STATE OF CONNECTICUT
CONNECTICUT SITING COUNCIL

RE: **PETITION NO. 1222A** - Windham Solar LLC declaratory ruling that no Certificate of Environmental Compatibility and Public Need is required for the proposed construction, maintenance and operation of three 2.0 Megawatt and four 1.0 Megawatt Solar Photovoltaic Electric Generating facilities located southeast of Hartford Turnpike and south of Fisk Road, Hampton, Connecticut. **Reopening of this petition based on changed conditions pursuant to Connecticut General Statutes §4-181a(b).**

Petition No. 1222A
Interrogatories
December 30, 2020

| SHEET NO. 4 | |

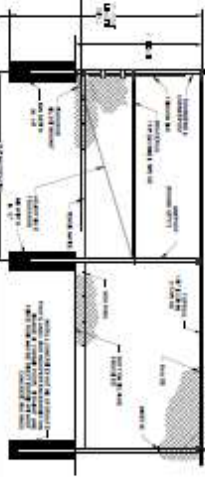
2. Windham Solar, LLC (WS) noted that the Future Projects were denied by the Council. However, attached Sheet No. 4 dated June 15, 2018 indicates three 1 MW AC Future Projects array areas. Please provide a corrected Sheet No. 4 with array labeling consistent with Sheet No. 15 – Landscaping Plan.

3. Referencing attached Sheet No. 4 dated June 15, 2018, to the east of the access drive, WS depicts the 6 MW AC of solar arrays already approved by the Council. On August 16, 2019, the Council approved the Development and Management (D&M) Plan for the clearing of the 6 MW approved array area and construction of 4 MW of the approved arrays. What is the current status of the construction of the 4 MW of arrays? Indicate when WS plans to submit an additional D&M Plan for the remaining approved 2 MW array.
